# PAR Change for P802.3bt

v121

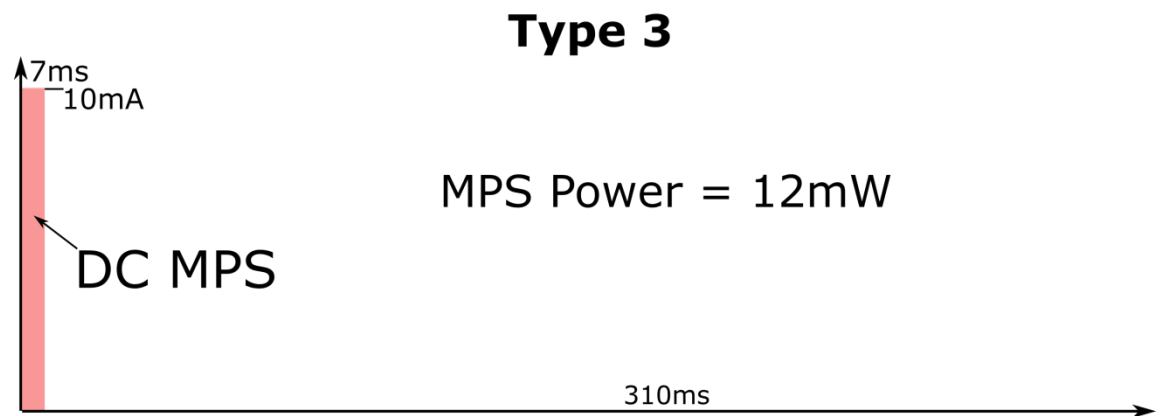
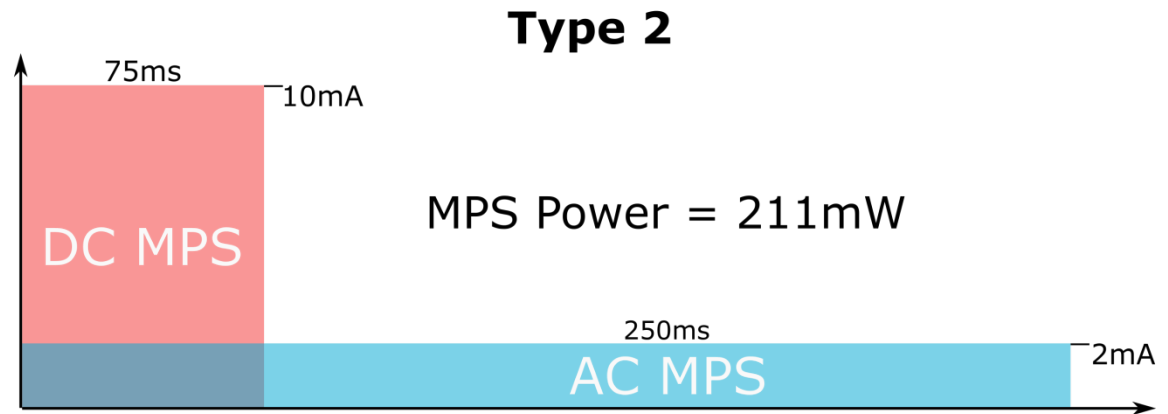
**5.2.b. Scope of the project:** The scope of this project is to augment the capabilities of the IEEE Std 802.3 standard with 4-pair power and associated power management information. The project will augment the methodology for the provision of power via balanced cabling to connected Data Terminal Equipment with 802.3 interfaces. Optional augmented power limit will be made available for certain structured cabling systems. Compatibility with existing equipment will be maintained.

**5.2.b. Scope of the project:** The scope of this project is to augment the capabilities of the IEEE Std 802.3 standard including 4-pair power and associated power management information. The project will augment the methodology for the provision of power via balanced cabling to connected Data Terminal Equipment with 802.3 interfaces. Optional augmented power limit will be made available for certain structured cabling systems. Enhancements, excluding the augmented power limits, introduced for 4-pair systems may be defined for 2-pair systems. Compatibility with existing equipment will be maintained.

- 802.3bt is creating two new Types (PSE & PD)
  - **Type 3** allows **60W** PSE power
  - **Type 4** allows **90W** PSE power
- New features have been added to these new Types that also provide benefit for 2-pair systems at power levels addressed by Type 1 (802.3af) and Type 2 (802.3at)
- Type 3 PSEs are allowed to operate over 2P only with maximum power of 30W and provide these new features. This requires a PAR change.
